AGENDA ITEM

SUBJECT: July 27, 2021 — Consent Item
Environmental Protection Commission Recommendation for
Request for Waiver and Variance for Christopher and Amber
Reeves Dock Construction Permit BD-21-02-019

Subject: Christopher and Amber Reeves Request for Waiver and Variance for Dock Construction Permit BD-21-02-019

REEVES BOAT DOCK SITE PLAN
1614 LAKESIDE DRIVE
ORLANDO, FL 32803

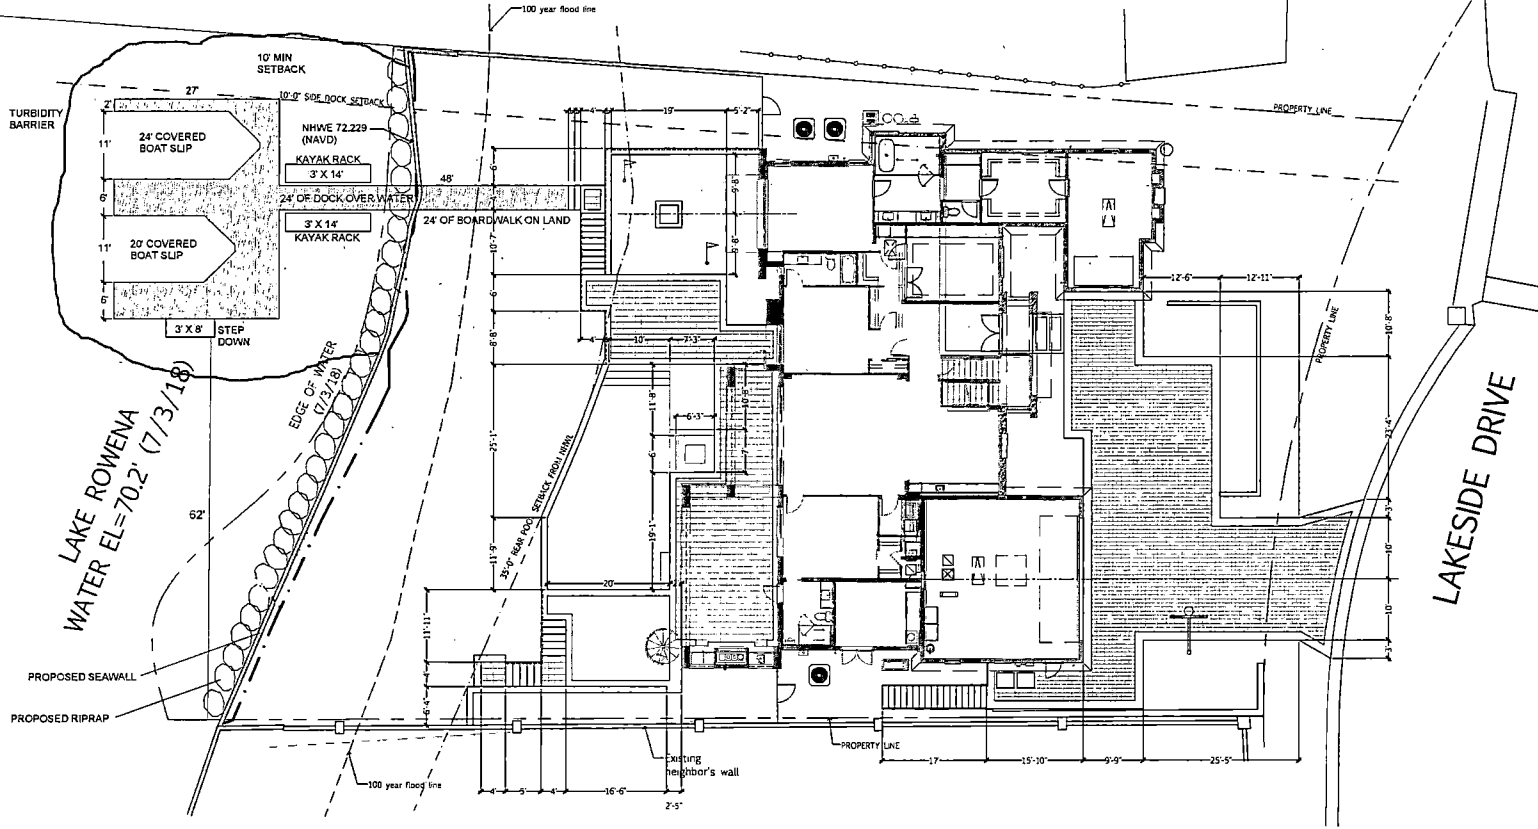
Chairman Ausley asked if the kayak racks will be enclosed and if the three foot by eight foot “step down” area on the site plan was included in the terminal platform size, to which Ms. Cichra responded yes. Vice Chairman Anderson stated that he cannot see any other double boat slip docks on the lake and asked why the applicants are proposing one. Ms. Cichra responded that the previous dock was not large enough to accommodate the applicants’ two boats. Chairman Ausley asked if only a small portion of the roof is proposed to exceed the maximum height requirement, and the agent confirmed that was the case. EPC Board Member Elaine Imbruglia asked for the size and condition of the previous dock that was onsite. The agent stated again that it was too small (roughly 800 square feet) to accommodate both of the applicants’ boats. The applicant, Christopher Reeves, stated that the previous dock required renovations. Ms. Liz Johnson from EPD confirmed that the objector was not present at the hearing. Chairman Ausley closed the public hearing; he stated he has no issue with the requests and that the mitigation offered is sufficient to offset shading impacts for the larger terminal platform size. EPC Board Member Billy Butterfield pointed out that they did receive an objection and he understands how the extra roof height may be an issue to neighbors.

The applicant has a shoreline that measures 116 feet at the Normal High Water Elevation (NHWE), which allows for a maximum terminal platform size of 955 square feet. The applicant is requesting a terminal platform size of 1,116 square feet (161 square feet over what is allowed).

Chapter 15, Article IX, Section 15-342(e) of the Code states, “The maximum roof height shall be no higher than twelve (12) feet above the floor elevation.” The applicants are requesting a roof height of 14 feet above the floor elevation of the dock.

Based upon evidence and testimony presented at the hearing, the EPC voted to overturn the findings and recommendation of the EPO by a vote of three to two, and recommended approval of the variance to Section 15-342(e) (roof height) and approval of the request for waiver to Section 15-342(b) (terminal platform size) with a mitigation payment of \$725 to the CTF.
